SERVICE BULLETIN

APPLICABILITY: 2020-21MY Legacy and Outback

NUMBER: 12-314-21

SUBJECT: Front Door Weatherstripping- Design Change

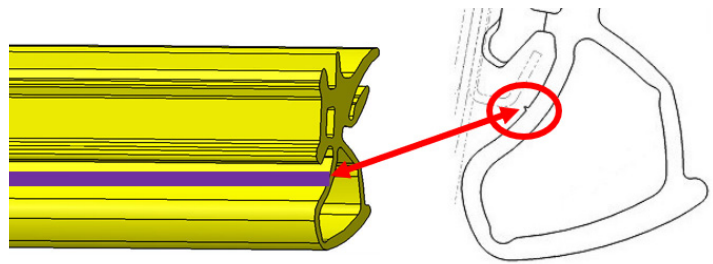
This bulletin announces availability of new weatherstrips designed to eliminate a squeaking / chirp -type sound heard when closing the front doors. The sound is audible when air trapped in the gap between sections of the weatherstrip is squeezed out as the door closes against the vehicle body. The shape (cross-section) of the weatherstrip was changed to reduce the amount of trapped air and eliminate the sound as shown in the illustrations below.

A small ridge has been molded in for identification.

- 63511AN00C for the **RIGHT** front door
- 63511AN01C for the **LEFT** front door.
